Subject: Joint Federal/State Application of Calvert Cliffs 3 Nuclear Project, LLC and UniStar Nuclear Operating Services, LLC, Calvert Cliffs Nuclear Power Plant Site, Lusby, Calvert County, Maryland, USACE Tracking No. NAB-2007-08123-M05

Application NAB-2007-08123-M05
Response to U.S. Army Corps of Engineers Information Request Dated 01/16/09
Calvert Cliffs 3 Project, LLC and UniStar Nuclear Operating Services, LLC
February 12, 2009

FIGURE 4A
 FISH RETURN

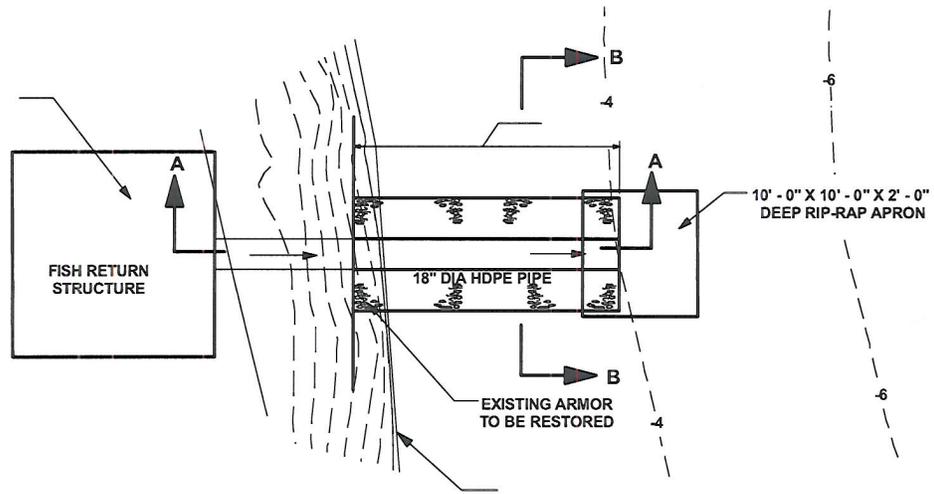
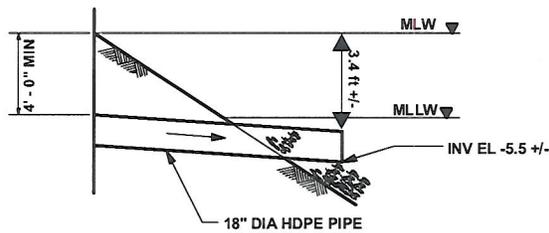
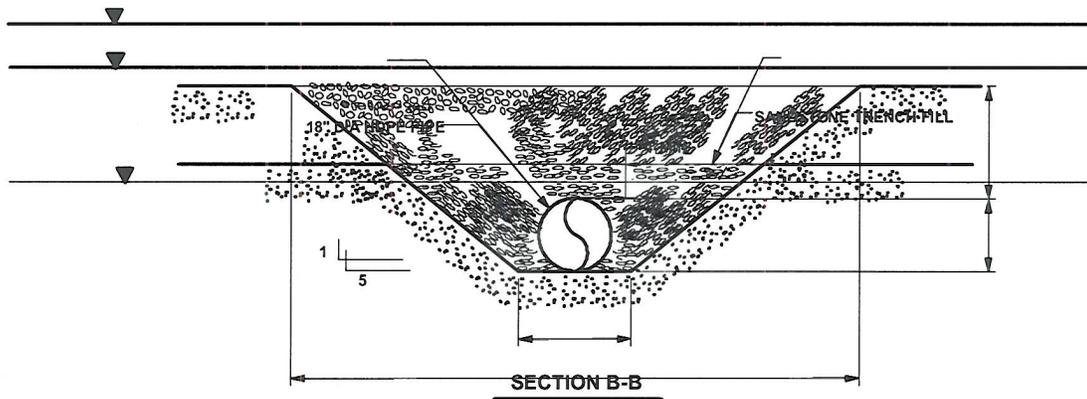
Provide depth from the top of pipe to mean low water for discharge pipe and fish return.

The clearance for the top of the fish return at mean low water is approximately 3.4 ft as noted in Revised Figure 4A (attached). The clearance for the top of the discharge pipe at mean low water is approximately 6.0 ft as noted in Revised Figure 5C (attached). The discharge pipe will be identified by markers as required.

- NOTES: 1. -MEAN HIGH WATERLINE: 0.57'
 -MEAN LOW WATERLINE: -0.60'
 -MAXIMUM SPRING WATERLINE: 1.47'
 -THE DISTANCE FROM THE TOP OF THE FISH RETURN PIPE TO THE MEAN LOW WATER LINE WILL BE APPROXIMATELY 3.4 FT +/-
